ELK HOUSE INTERIORS

01 GROUND FLOOR PLAN
SUGGESTED RCP AND SMALL POWERS
NTS

02 FIRST FLOOR PLAN
SUGGESTED RCP AND SMALL POWERS
NTS

CLIENT O' Reilly Hyland Real Estate	
PROJECT NAME The Paddocks, Coolcotts Lane, Co. Wexford	
DRAWING NAME SUGGESTED RCP and SP PLAN - HOUSE TYPE D1	
DRWG NO	DRWN/CKD BY
REV A	SCALE NTS

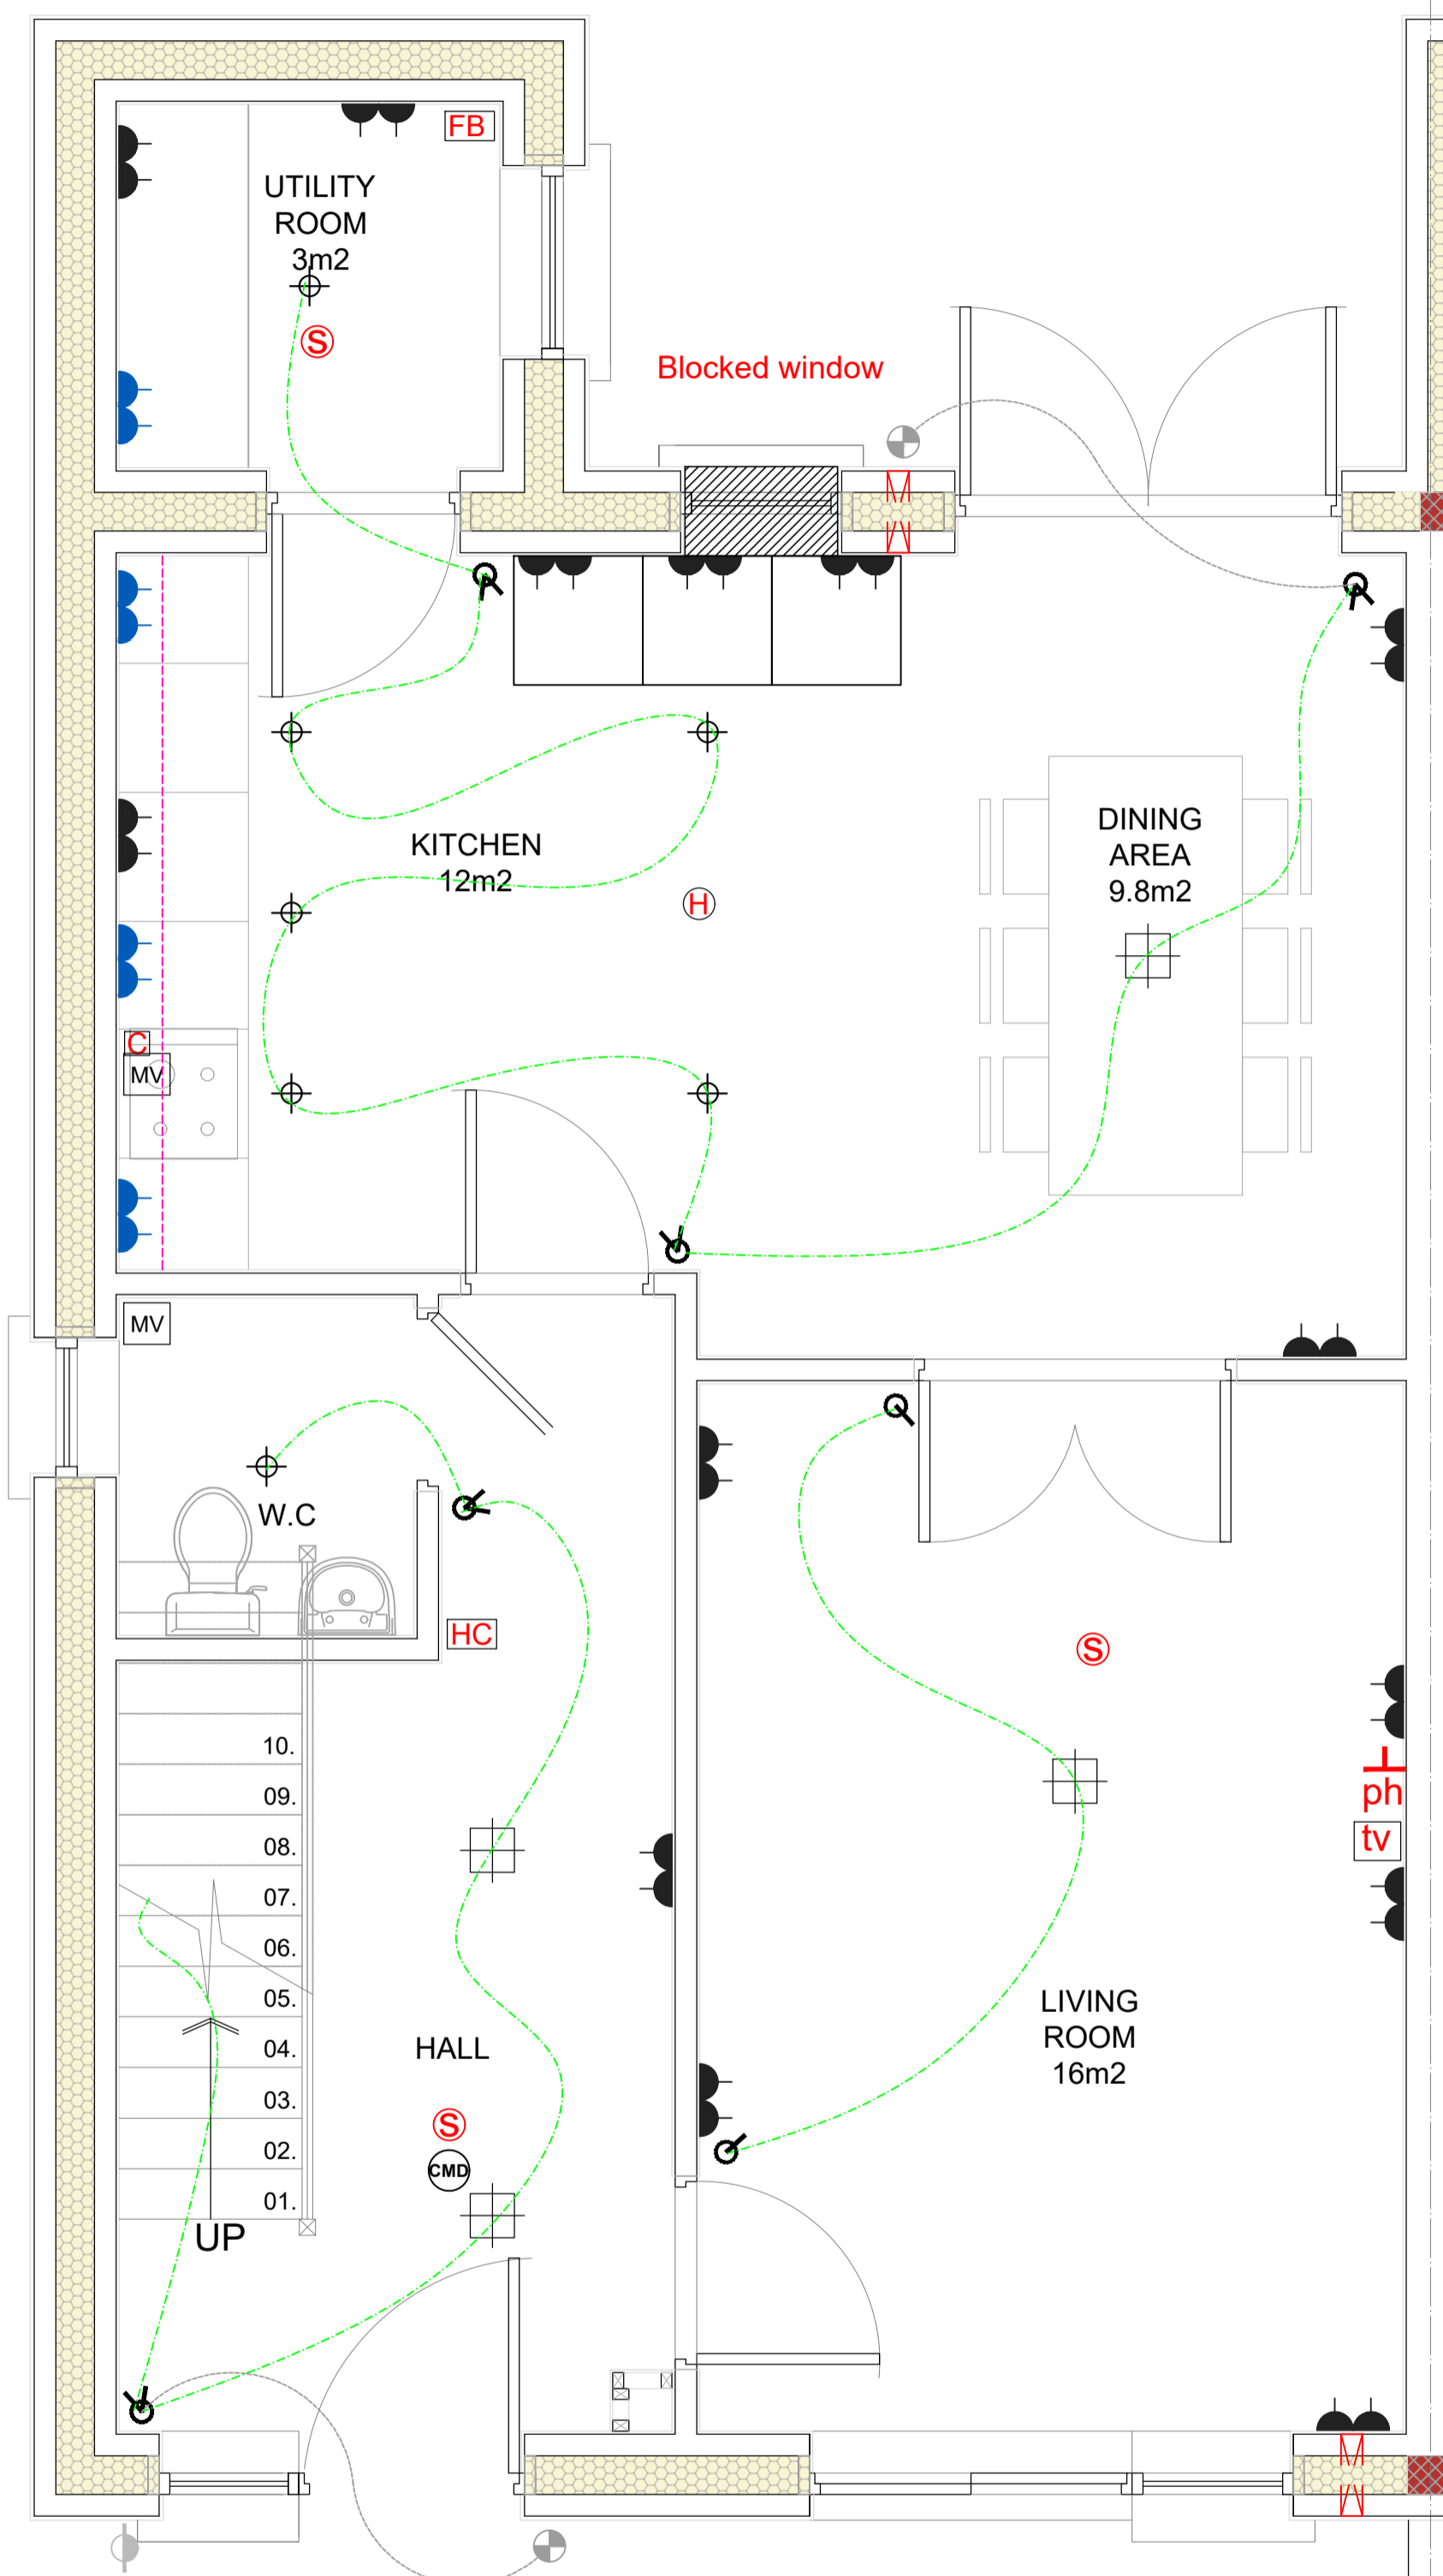
ON GROUND FLOOR THE KITCHEN DESIGN HAS BEEN UPDATED.
ELECTRICAL LAYOUT HAS BEEN REVISED ACCORDINGLY.
CLIENTS TO CONFIRM IF KITCHEN WINDOW IS TO BE REMOVED
FROM PLANS
***ELECTRICIAN TO CONFIRM LAYOUT*.**
